MPCP FEC issues: Delay In Tx PCS

Jeff Mandin - PMC-Sierra
802.3av TF – New Orleans
January 2009

Remedy: Figure 77-13 (OLT control mux)

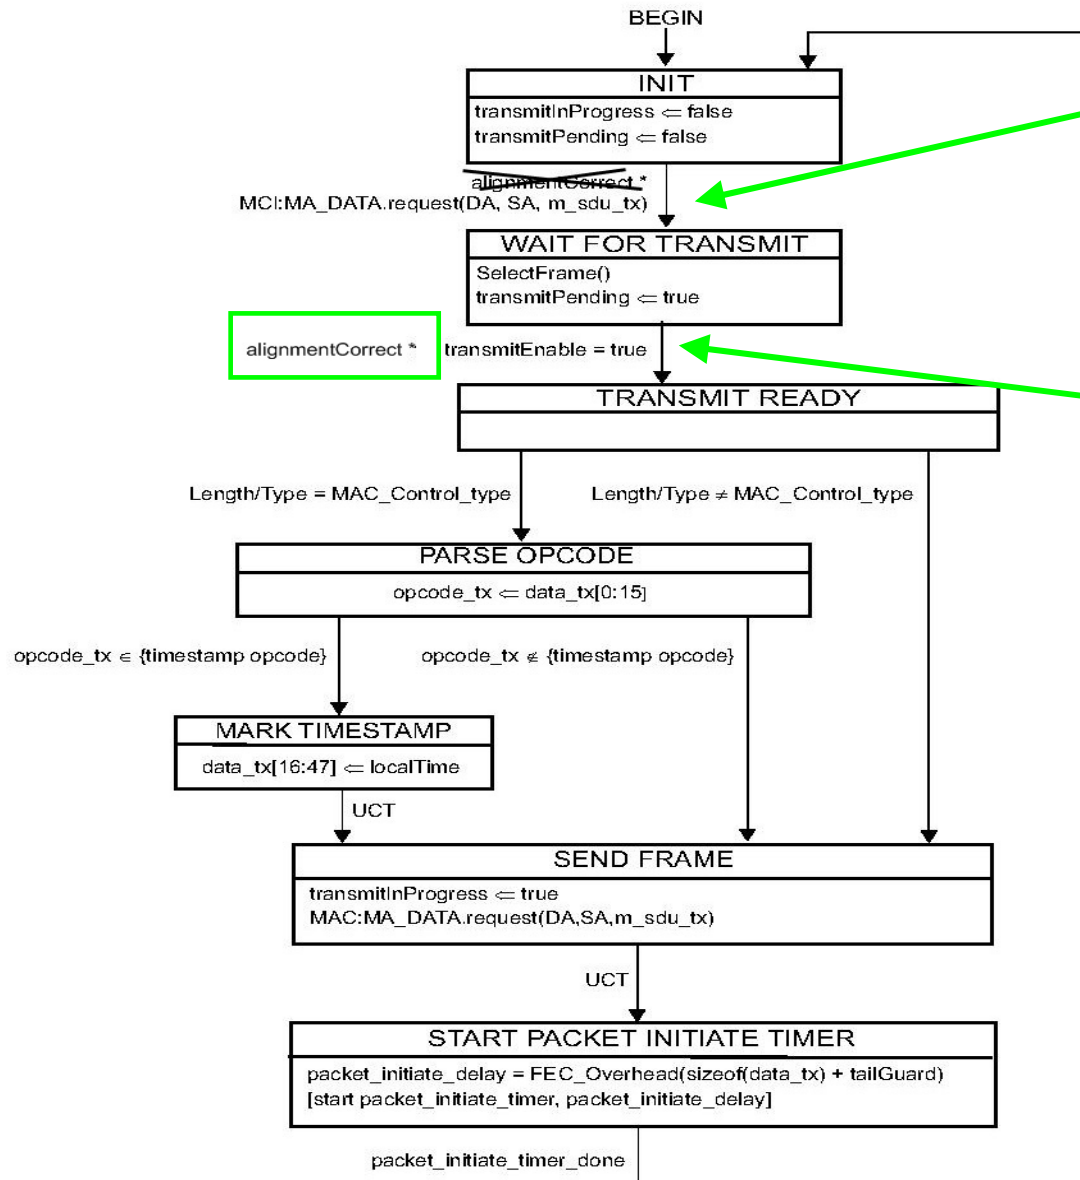
Delay in OLT Tx PCS

1. **First**, the Control Mux delays the frame transmission (if necessary) until an interval when the PCS will transmit payload data rather than parity

2. **Next**, the frame is delayed again until the particular MAC receives permission to transmit

But after this second delay, the PCS may in fact be transmitting parity.

If so, the frame will experience delay in the Tx PCS of up to 32 byte times

1. Remove this check for what the PCS is transmitting (as the MPCP instance must anyway wait for transmit permission)

2. After the MPCP instance has received permission to transmit, check whether PCS is transmitting parity and delay if necessary
